**Packet Guide**  
**City of Charlottesville**  
**Board of Architectural Review**  
**Regular Meeting**  
**June 16, 2026 5:30 p.m.**  
**Hybrid Meeting (In-person at Council Chamber and virtually via Zoom)**

BAR # 26-0025

BAR # 25-0095

# Solar Study

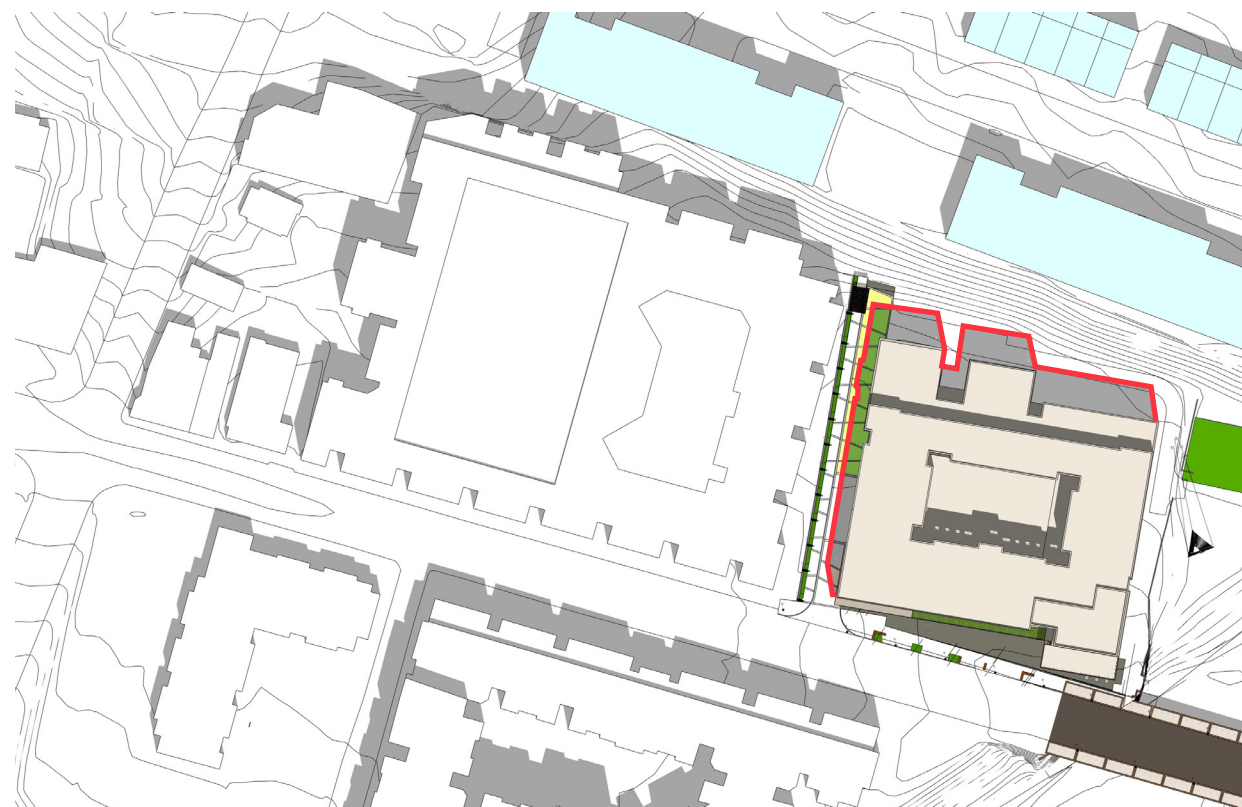
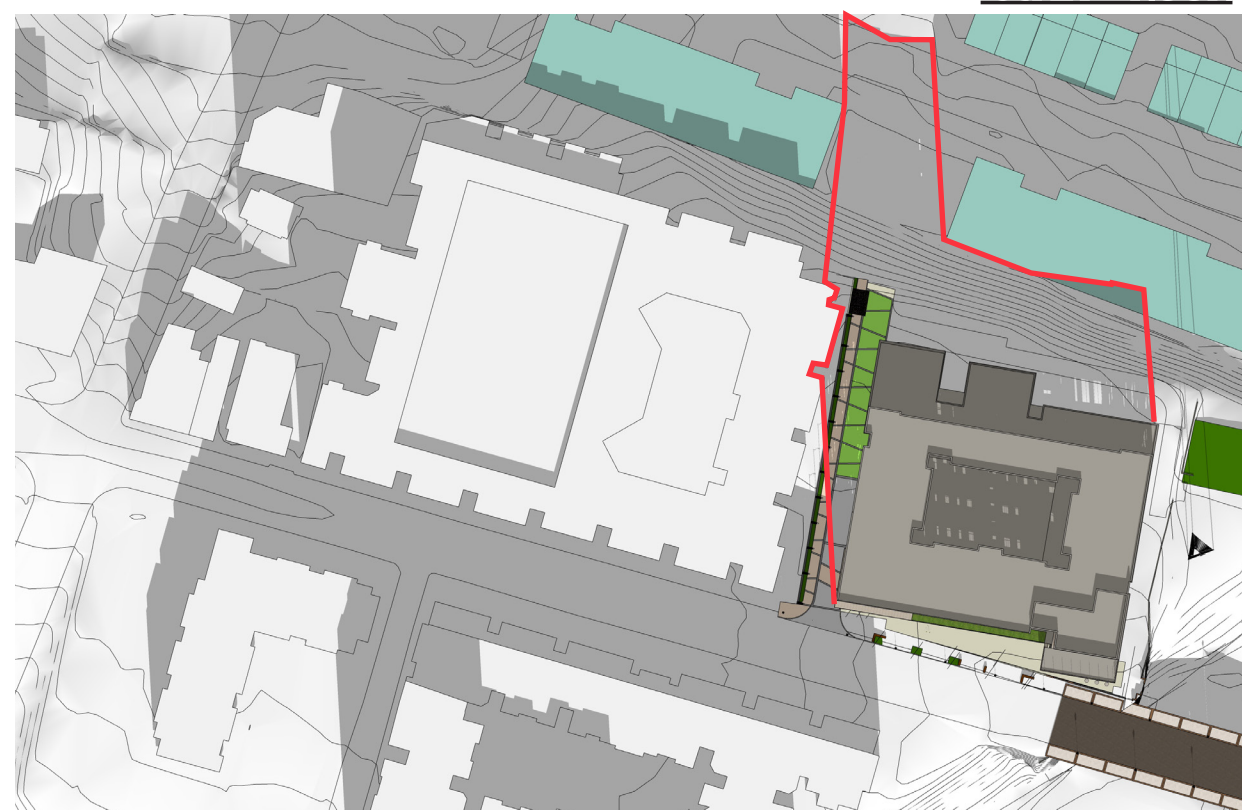
- Provide a solar/shade study.
  - Staff comment: Submittal includes a Solar Study, see page 13.

# Level 8

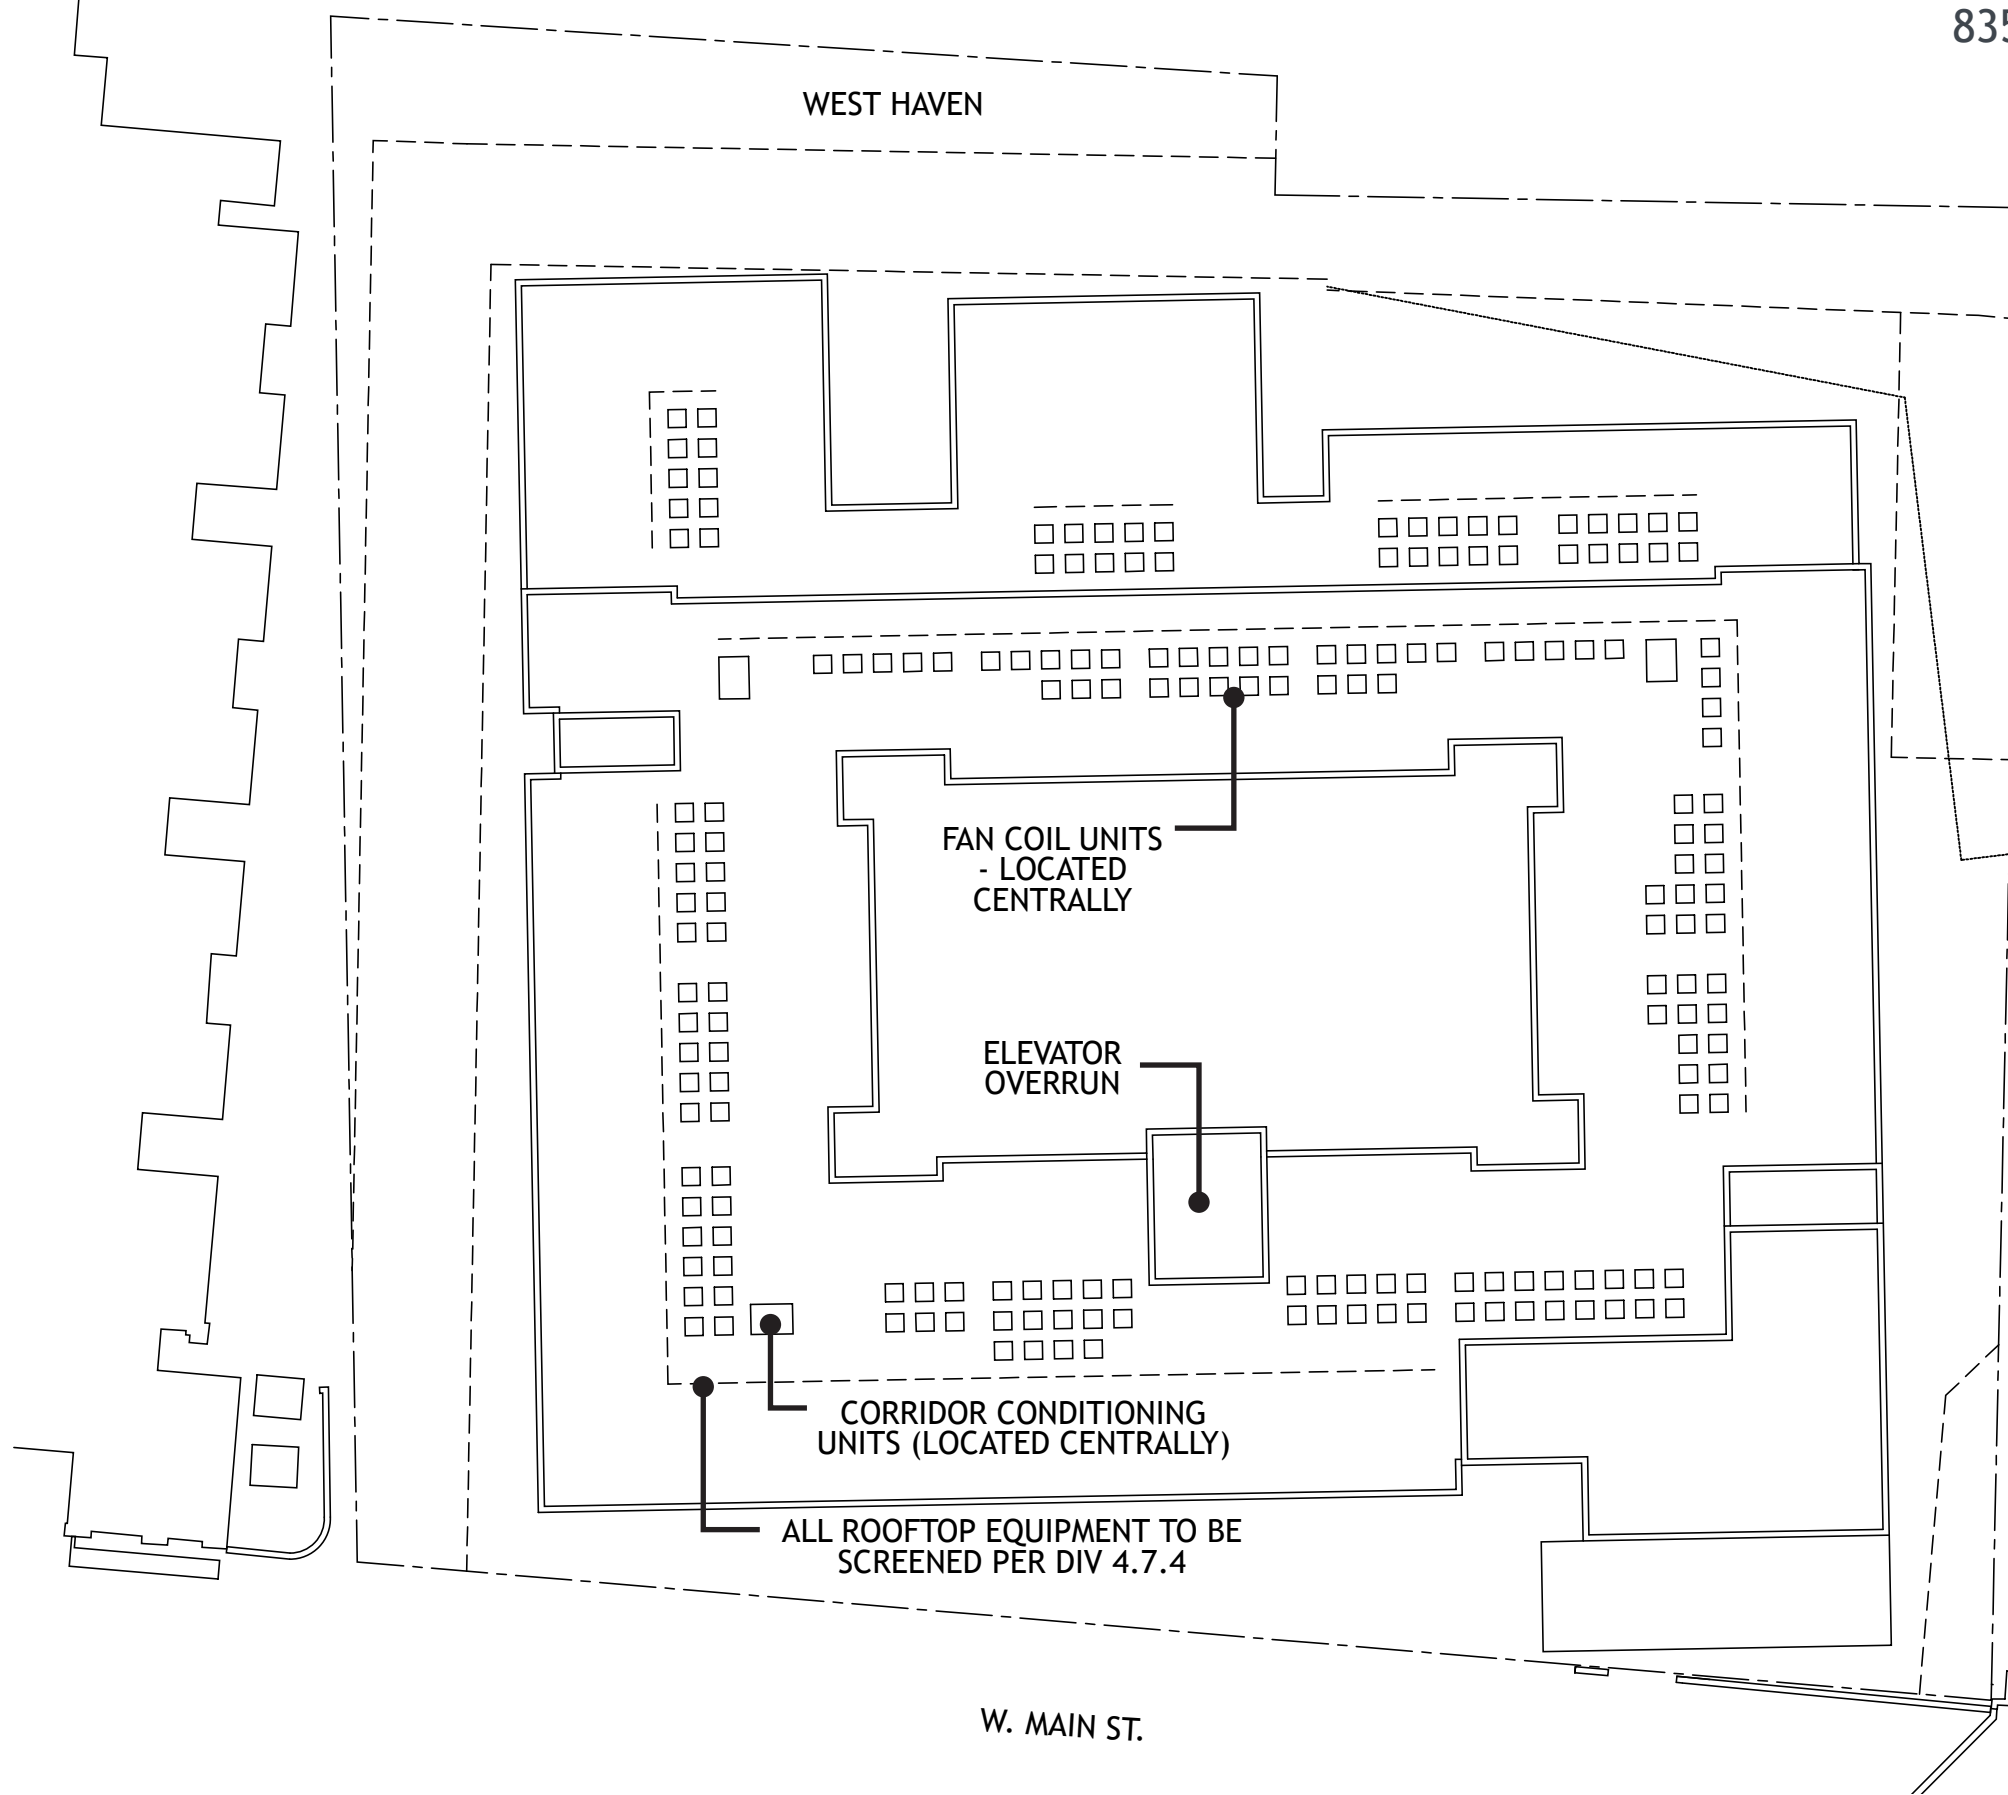
- Rooftop screening required by Code of Development.
  - Staff comment: The Code of Development (Div. 4.7.4.) requires parapet walls be 6” higher than top of rooftop equipment, regardless of equipment location. Drawings indicate a 4-ft parapet. Unless equipment will be under 3’-6”, either the parapet must be taller, or additional screening will be required. This is a code requirement, so not discretionary by the BAR; however, to later comply with this code provisions, if additional screening is required and/or the parapet height must be altered, BAR approval of those design changes may be required.

ALL MECHANICAL UNITS TO BE LOCATED OVER THE RESIDENTIAL CORRIDORS. A MINIMUM DIMENSION OF 10'-0" TO BE MAINTAINED BETWEEN EQUIPMENT AND PARAPET. ALL MECHANICAL EQUIPMENT TO BE SCREENED PER DIV. 4.7.4 OF THE CHARLOTTESVILLE CODE OF DEVELOPMENT

# Wall Sections

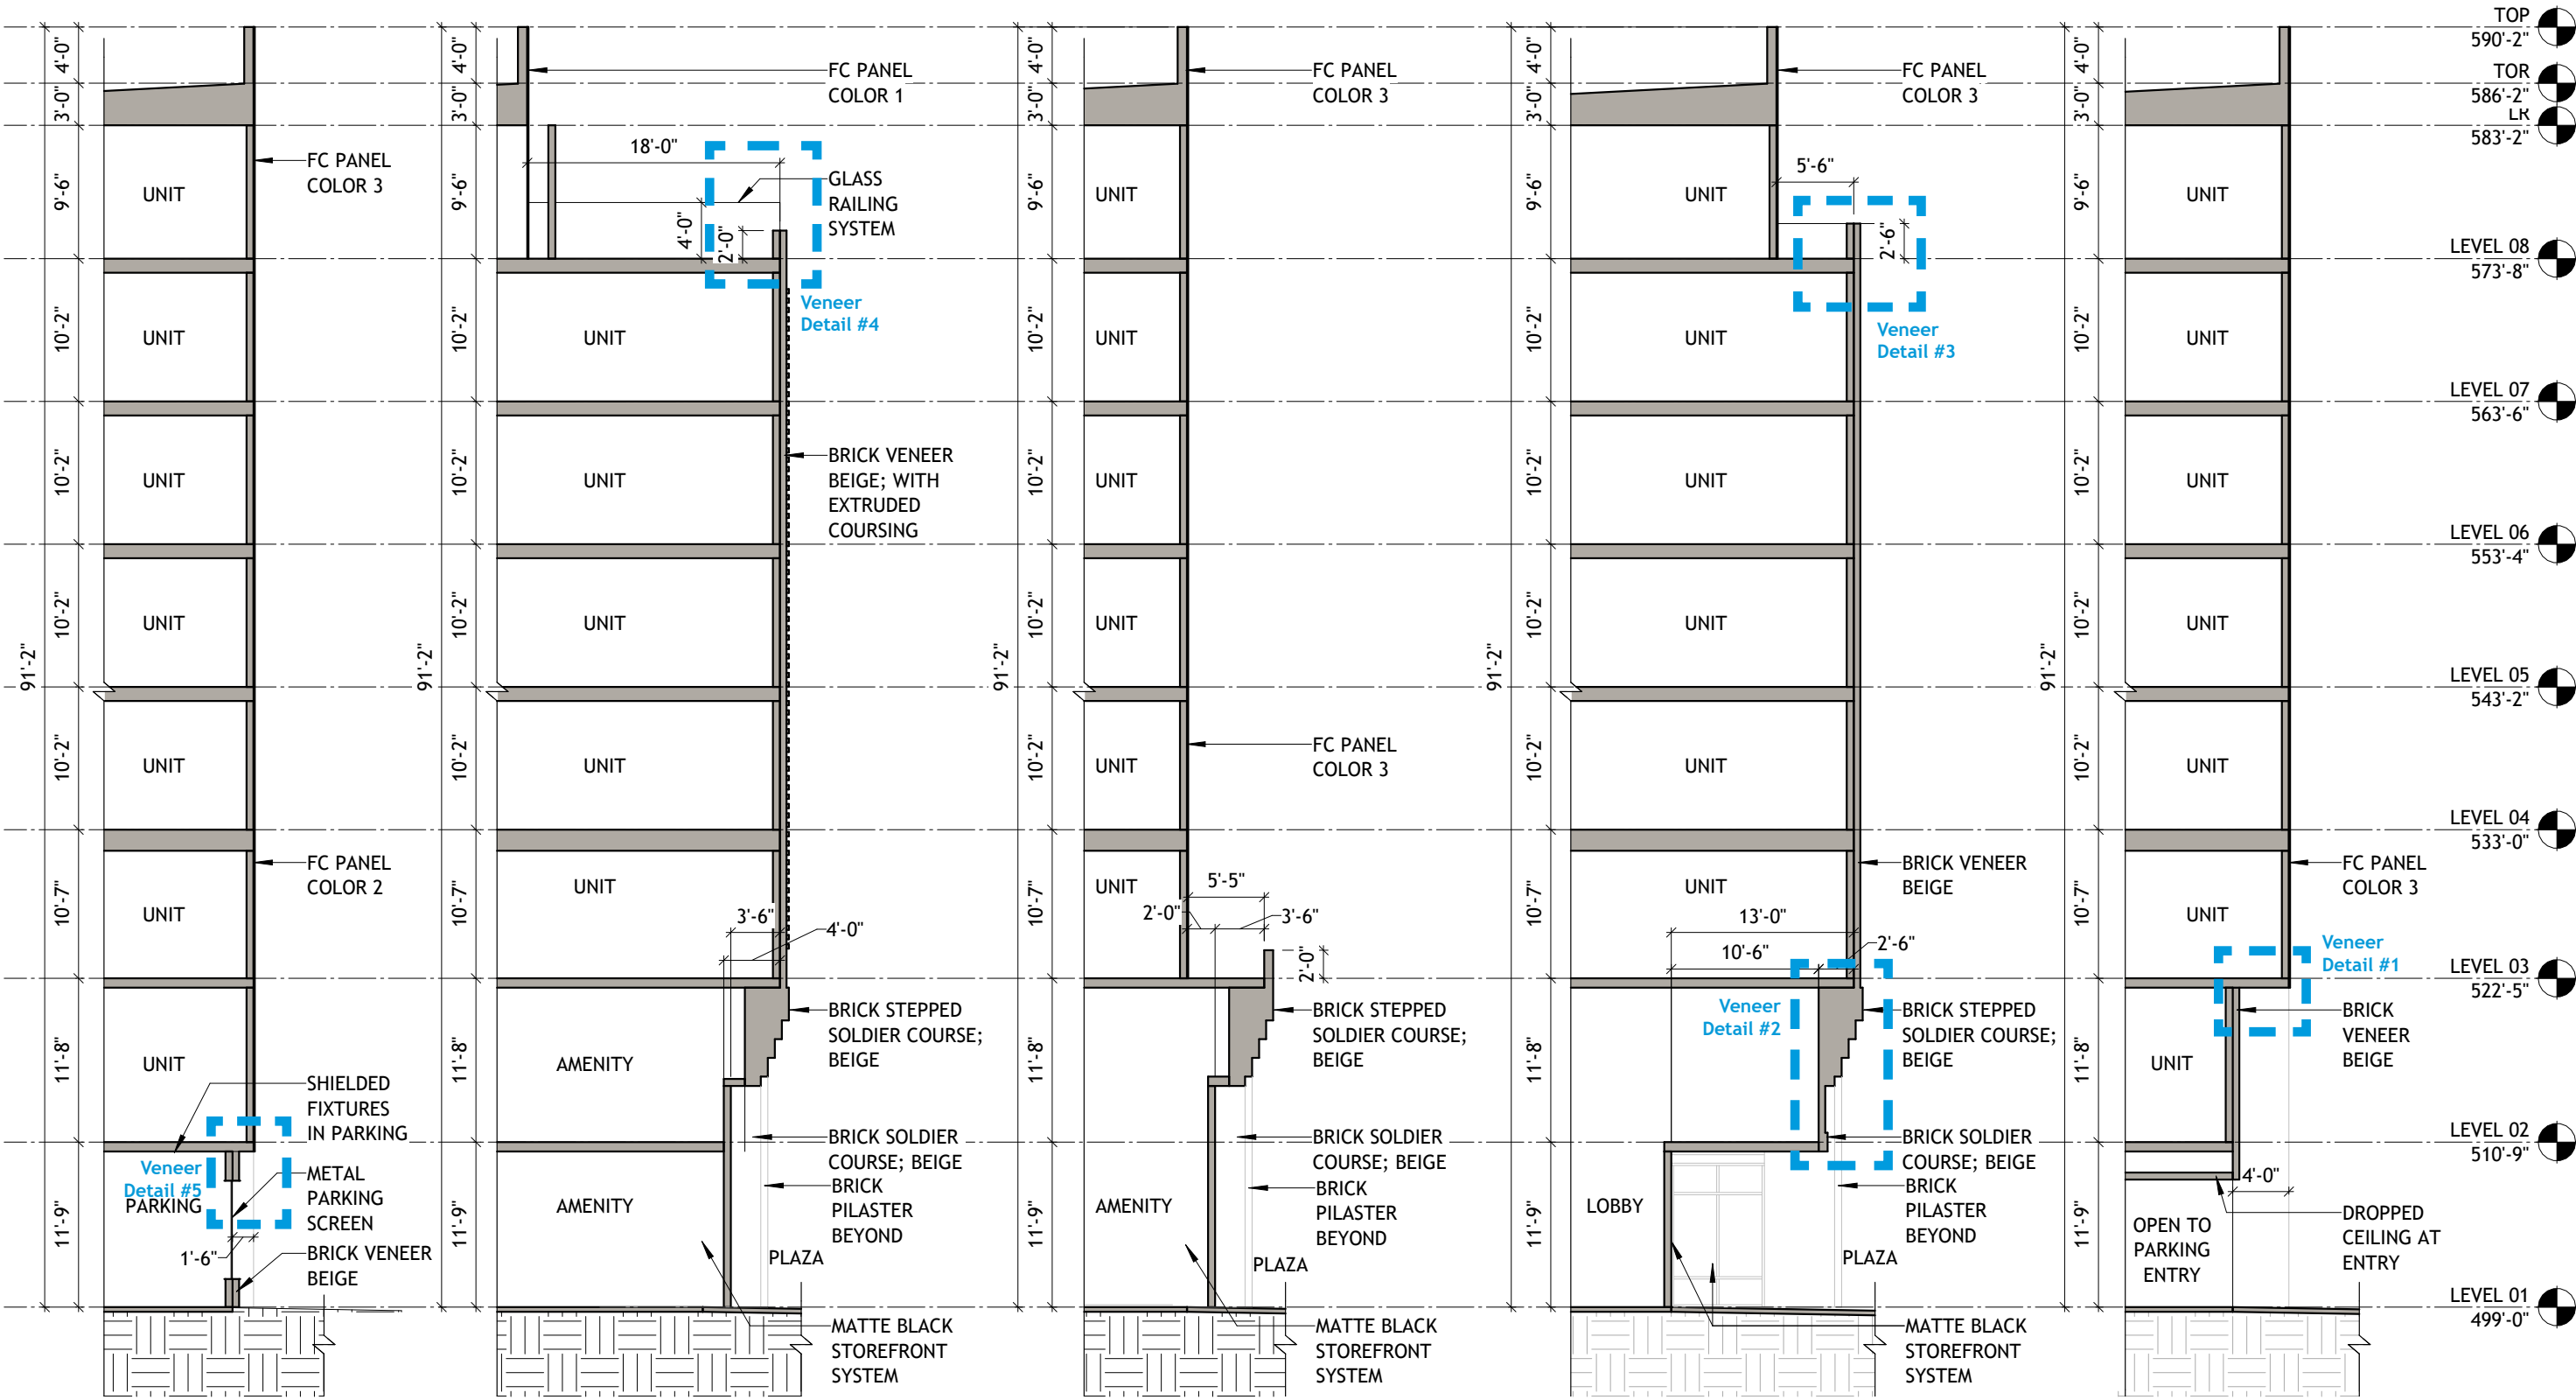
- Provide brick details and corbelling; show masonry depth in wall sections
  - Staff comment: See wall sections and details on pages 33 through 39.
- Suggested a cornice feature.
